UNITED STATES PATENT AND TRADEMARK OFFICE

APPLICATION NO.	FILING DATE	FIRST NAMED INVENTOR	ATTORNEY DOCKET NO.	CONFIRMATION NO.
09/855,853	05/15/2001	Stefan J. Murry	PAT013	1173

Office Action Summary

DETAILED ACTION

Fig. 2B

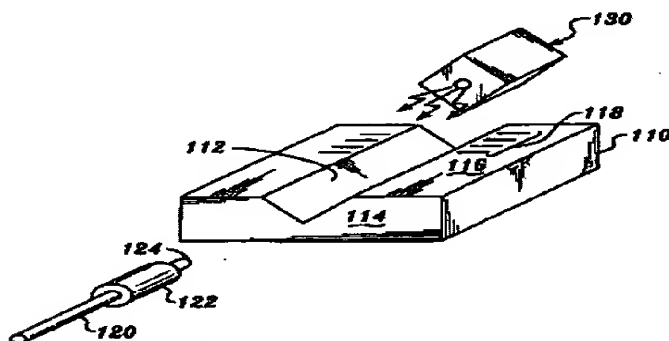
Claims 62,64,70 and 71 are rejected under 35 U.S.C. 102(b) as being anticipated by Beranek et al (PN 5,896,481).

In figure 2B Beranek et al illustrates a silicon optical bench (110) having an etched groove (112) for mounting and aligning a vertical cavity surface emitting laser (VCSEL) with an optical fiber (120), which receives the emitting laser beam of the VCSEL. The emitted beam is parallel with the optical bench and is directly coupled with optical fiber.

FIG. 6

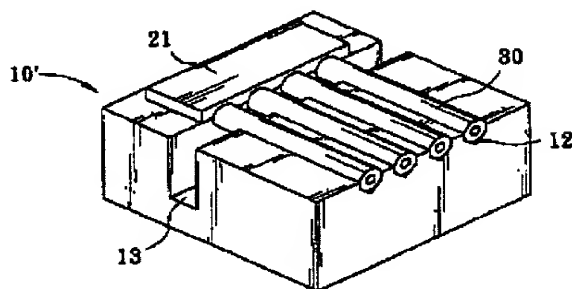
In figure 6 Wu et al illustrates an array of vertical cavity surface emitting lasers (21) mounted on a slot (11) (not shown see figure 2 and an array of optical fibers (30), where the lasers and the fibers are all mounted on a silicon substrate. The lasers emit a light, which is optically coupled to the edge of the fiber.

Therefore, it would have been to a person having ordinary skill in the art at the time the invention was made to duplicate the alignment structure of Beranek et al as

taught by Wu et al to obtain an array of VCSEL aligned with optical fibers for receiving the emitted laser beam.

FIG. 1A

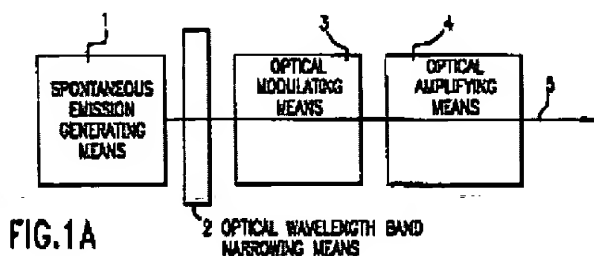
Beranek et al does not disclose coupling modulators, amplifiers and SOA with the array of lasers.

Coupling of optical modulators, optical amplifiers or any other optical element within a laser system is well known in the laser art and would be within the level of skill of any person having ordinary skill in the art, which understands the scientific and engineering principles applicable to the claimed invention, as shown in figure 1A of Ota et al where a laser is optically coupled to a modulating means and an amplifying means.
